Subject: RE: [EXTERNAL] De Anza Natural Plan

Good afternoon. I appreciate your taking the time and energy to give us feedback on the draft De Anza Natural amendment to the Mission Bay Park Master Plan. We welcome your participation as the project moves through the process.

Subject: [EXTERNAL] Comment on the De Anza Cove Amendment to the Mission Bay Park Master Plan

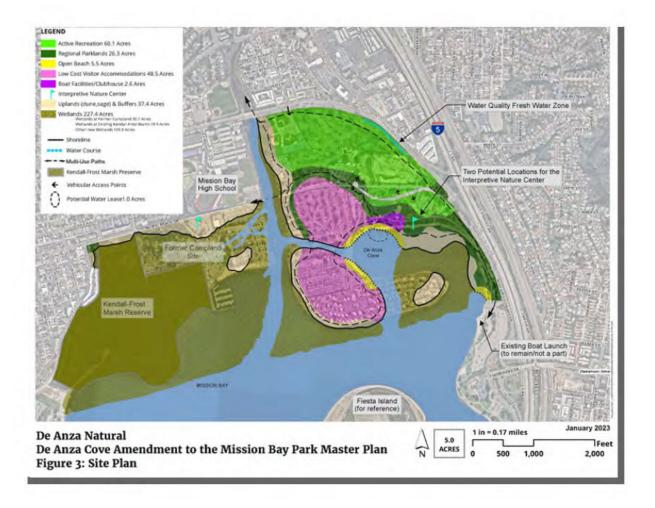
Is there a chance you can add a legend map to augment this existing conditions graphic for DeAnza so we can compare existing and proposed uses and acreages and weigh all the factors in terms of acres for each alternative.
